DATE	REV.	DESCRIPTION		NAME
21.09.2010	01	Modify to the central screw --->NEW CENTRAL SCREW OPEN		LORENZO CIMMINO
08.07.2011	02	Changed the diameter of the hole of the nut from 21.7mm to 22.1mm		LORENZO CIMMINO
08.07.2011	03	Changed the diameter of the base		LORENZO CIMMINO
08.07.2011	04	Changed the thickness of the o-ring from 1.8mm to 1.6mm		LORENZO CIMMINO
TOLLERANZE		DESIGNATORE	DATA	DISIGNO N.
UDM	ANGOLO	CONTROLLATO	20.12.10	1:1
DESCRIZIONE		TP0	MATERIALE	
CIRCULAR BASE FOR DIN4,3650/A WITH M27X1.5 FIXING NUT		BASIS		
2POLES+EARTH WITH RIDUCTION FROM M27X1.5 TO PG13.5

CODE
BGRN02000-PG13,5

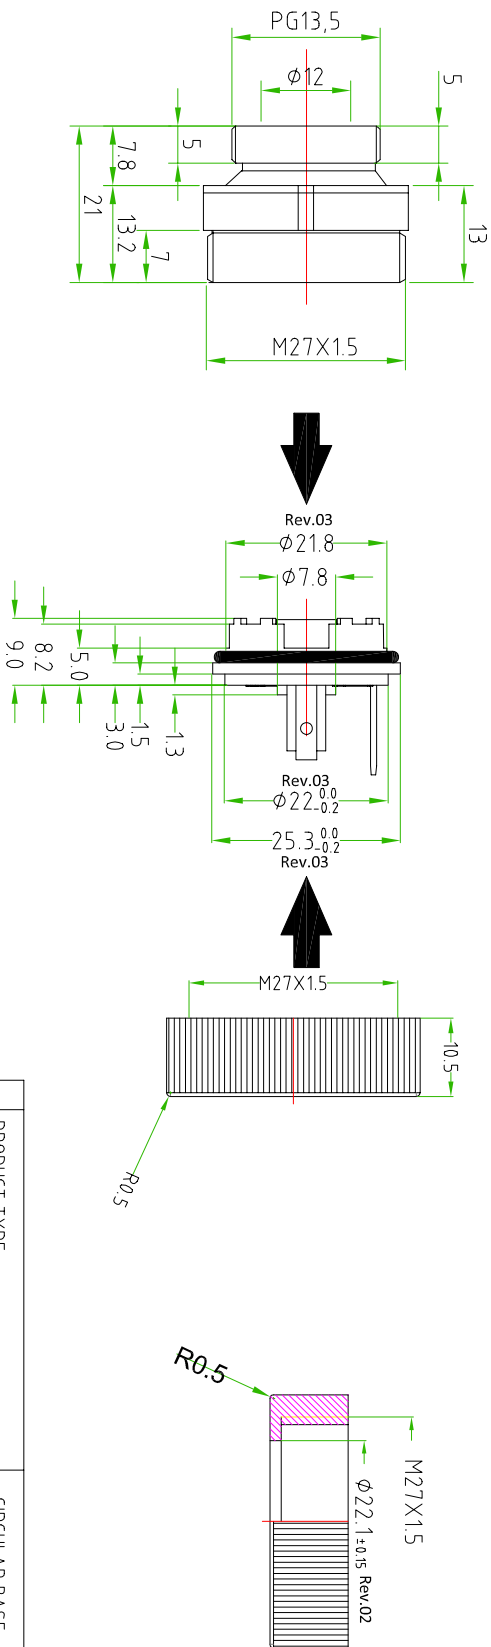
Rev.01
CENTRAL SCREW OPEN
